Access Compliance Report

Public Rights-of-Way

(Curb Ramps)

Intersection ID: 15247	Main Street: E_INDEPENDENCE_BV	Cross Street: EASTWAY_DR_RA	Location: NE
ADA ID: 0FB25F4C29F5	Ramp Type: Perp	Initial Pass/Fail: Fail	Overall Compliance: No
Codes/Mitigation Info/Possible Solution			Severity Score: 10
			Field Measurements/Component Compliance

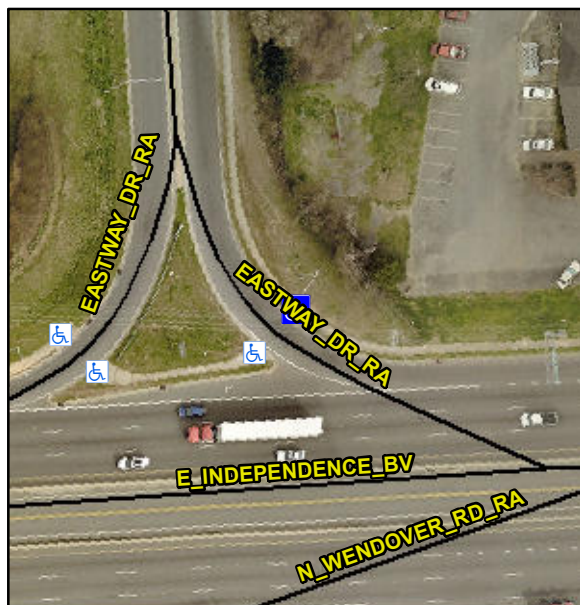
Not Found, R304.5.1, R304.5.3

Compliance	Description	Data	Compliance	Description	Data
N/A	Ramp Length (in)	88.0	Yes	Ramp Slope (%)	6.1
No	Ramp Width (in)	47.0	No	Ramp XSlope (%)	2.5
N/A	Flare Type LT	N/A	N/A	Flare Type RT	N/A
N/A	Flare Slope LT (%)	N/A	N/A	Flare Slope RT (%)	N/A
N/A	Flare Traversable LT?	N/A	N/A	Flare Traversable RT?	N/A
N/A	Landing Length (in)	N/A	N/A	DWS Provided?	N/A
N/A	Landing Width (in)	N/A	N/A	DWS Contrast?	N/A
N/A	Landing Slope (%)	N/A	N/A	DWS Length (in)	N/A
N/A	Landing X Slope (%)	N/A	N/A	DWS Full Width?	N/A
N/A	Landing Curb? (Y/N)	N/A	N/A	DWS Offset (in)	N/A
N/A	Shared Landing?	N/A			
N/A	Gutter Ponding?	N/A	N/A	Gutter Slope (%)	N/A
N/A	Gutter Lip Ht (in)	N/A	N/A	Gutter X Slope (%)	N/A
N/A	Painted X Walk1?	No	N/A	Painted X Walk2?	N/A
	X Walk 1 Direction	To SW		X Walk 2 Direction	N/A
N/A	X Walk 1 Width (in)	N/A	N/A	X Walk 2 Width (in)	N/A
	X Walk 1 Slope (%)	5.4		X Walk 2 Slope (%)	N/A
	X Walk 1 X Slope (%)	1.9		X Walk 2 X Slope (%)	N/A

Remove & Replace Entire Ramp.
